**STANDARD HIGHWAY
SPECIFICATIONS
VOLUMES I & II**

**ADDENDUM No. 1
October 15, 2010**

THE CITY OF NEW YORK
DEPARTMENT OF TRANSPORTATION

THE CITY OF NEW YORK
DEPARTMENT OF DESIGN AND CONSTRUCTION
INFRASTRUCTURE DIVISION
BUREAU OF DESIGN

TEMPORARY PEDESTRIAN STEEL BARRICADE

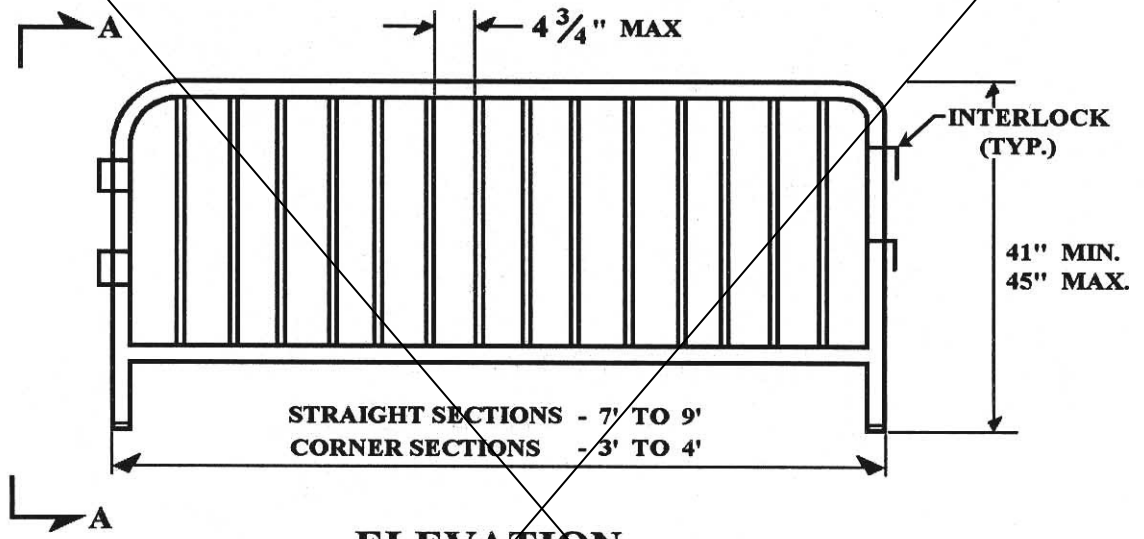
14. Refer to Page 500, **Subsection 7.36.3. MATERIALS**, first paragraph, second and third lines;
Delete in the first paragraph, the second and third lines beginning with the words "on the New York City Department of Transportation's Standard Details of Construction Standard Drawing No. H-1014";
Substitute the following text: "on the following sketch".

15. Refer to Page 501;
Insert the sketch contained on the following page A1-2d.

27. Refer to Page 501 as amended by Article 15, above;
Delete the Pedestrian Steel Barricade sketch, as contained on page A1-2d, in its entirety.

26. Refer to Page 500, **Subsection 7.36.3. MATERIALS**, first paragraph, second and third lines as amended by Article 14, above;
Delete in the first paragraph, the second and third lines the words “on the following sketch”;
Substitute the following text: “on the New York City Department of Transportation’s Standard Details of Construction Standard Drawing No. H-1014”.
